# Customer Notification

B-CN-113-CN Rev A

**SUBJECT:** Discontinuation of Reinforced Soft Start Variants

**Reinforced Soft Start**  
带加固件的软启动板

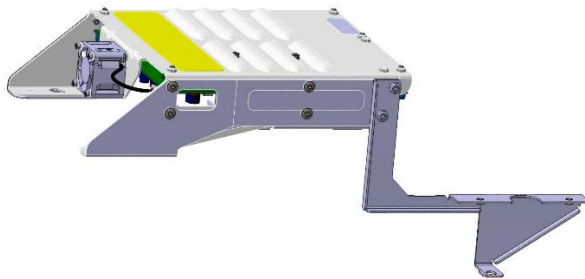
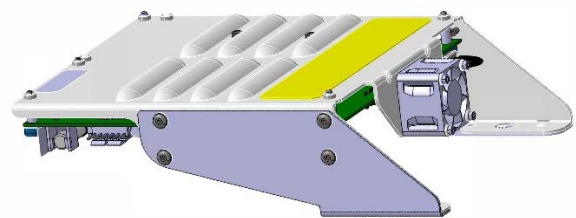
The purpose of this document is to notify customers that effective immediately, Danfoss Turbocor is no longer providing a variant of the soft start having special reinforcement. This version of soft start is an older support configuration used in some specialty applications. **It has been determined that the current design of the soft start does not require any additional special reinforcement.**

All affected spare part kits and some legacy compressor part numbers which included the reinforced version of the soft start are being discontinued. Any legacy compressor part numbers which are still available in a customer's price guide can still be ordered; however, they will have the standard soft start included as opposed to the reinforced variant.
